**Objection - 13 Belsize Crescent, London NW3 5QY
Planning Application: 2023/0692/P**

13 Belsize Crescent planning application

Photos of garden retaining walls and of trees.

Walls

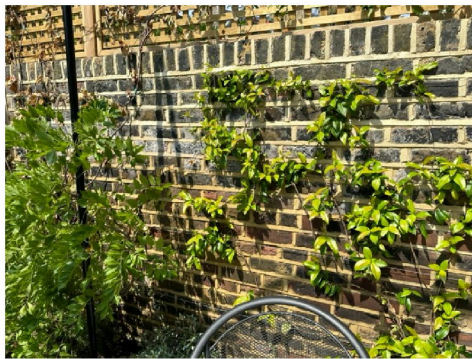
Unlike the brick party wall in the garden between 9 & 11 Belsize Crescent which is constantly dry, the brick party wall in the garden between 11 & 13 Belsize Crescent is constantly wet which points to an existing drainage issue (also linked to the sloping of the area). Based on the plans submitted, there is a reasonable expectation the issue would worsen with the loss of natural drainage (increasing the risk not only for the garden itself but for the lower ground floor which is at the same level)
